**RE: RESPONSE TO THIRD PARTY APPEAL IN RESPECT OF PROPOSED DEVELOPMENT AT A SITE LOCATED IN THE TOWNLANDS OF ROWANS BIG, ROWANS LITTLE, AND COURTLUGH, LUSK AND BALBRIGGAN, CO. DUBLIN**

**FINGAL COUNCIL REG. REF.: F24A/0362E**

**ABP CASE NUMBER: ABP-322429-25**

## **Response to TII Appeal Technical Queries**

**Figure 3.3: Masterplan overlain with Flood Map**

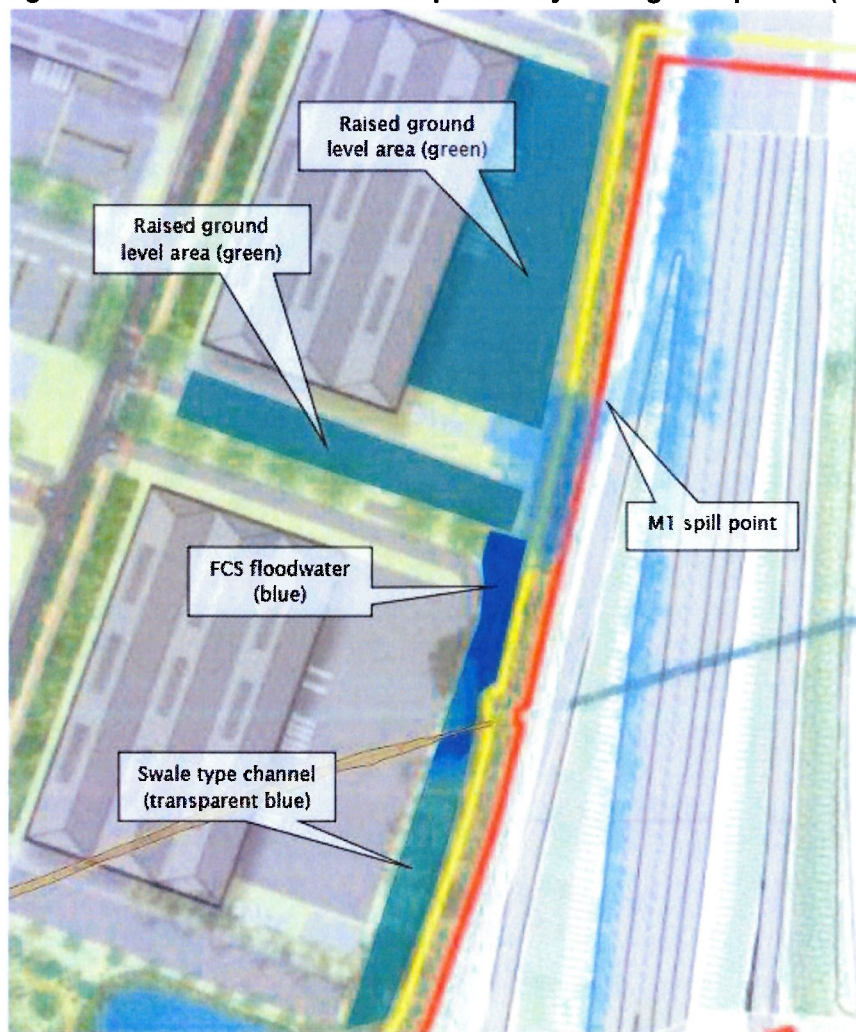
A Flood Risk Assessment (FRA) prepared by McCloy is submitted in support of the proposed development. As part of the further information response, McCloy's prepared a technical response to TII's claims that flooding as a result of the proposed development would impact on the adjacent motorway. McCloy's noted the following in relation to the masterplan:

*"While the submitted FRA considered roads and associated services only which were wholly located in Flood Zone C, a version of the masterplan for the site was provided by the Client and overlain with the Flood Zone map. As shown below, a marginal portion of the car parking in the east of the site is situated within the floodplain. It is noted that southern section of the site is not affected by flooding so only the northern areas is included."*

*This change to ground levels within a minor area of the floodplain has the potential to increase flood risk elsewhere and will require Flood Compensatory Storage (FCS) as described in the following sections".*

Figure 2-1: Western and eastern proposed pedestrian crossings and shared path active travel facilities interfacing with existing M1 Junction No. 5

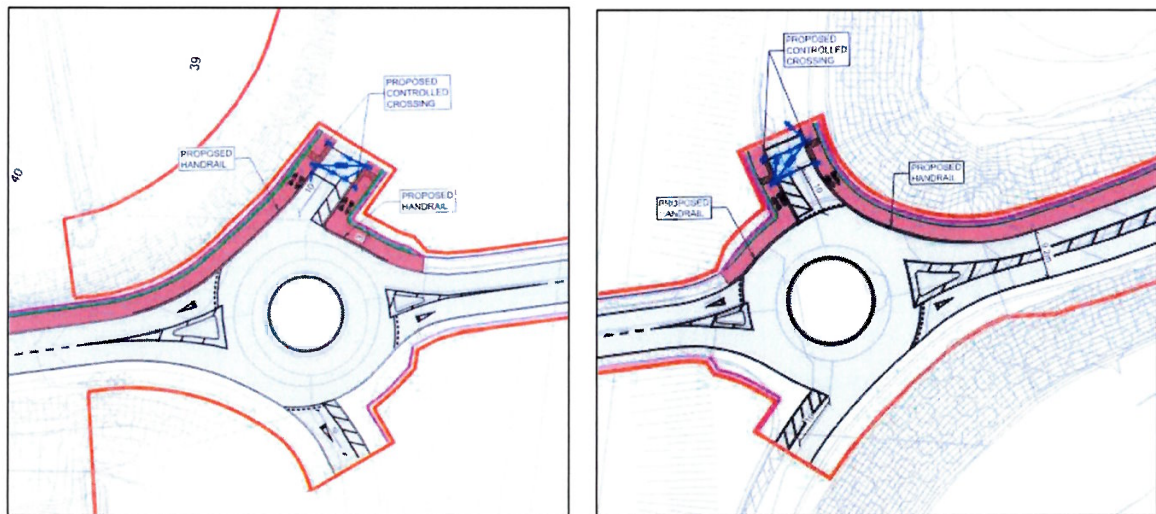
In response to TII's comments regarding non-compliance with TII Publications and inappropriate use of DMURS and the NTA Cycle Design Manual, the Applicant has undertaken a comparison of the relevant design parameters. A detailed table is included in **Appendix A** of this submission. This analysis compares the proposed cycle infrastructure against the requirements of TII Publications (specifically PE-PMG-02045 and DN-GEO-03047-04) and the NTA Cycle Design Manual.

The findings confirm that the proposed design meets TII's stated design criteria, including requirements for Dynamic and Stopping Sight Distances, Horizontal Radius, Gradient, Cross-Section Widths, and Junction Visibility. While the submitted planning design (left image) did not include the 1-metre minimum horizontal separation for roads with a 60 kph speed limit—due to more substantial embankment reconstruction works that would result. However, if the provision of the horizontal separation is preferable to TII, this can be achieved by reducing the path width to 2 m, thereby allowing for compliance with safety standards while minimising impacts on the layout, earthworks. Importantly, this adjustment would not give rise to any environmental impacts that have not already been identified and assessed as part of the submitted planning documentation and environmental assessments. Figure 2-1 below shows the proposed development layout submitted for planning (as amended following the Further Information Request) and Figure 2-2 shows an example of active travel infrastructure at roundabouts with the horizontal separation to road edge (extracted from TII publication DN-GEO-03060 Figure 7.5).
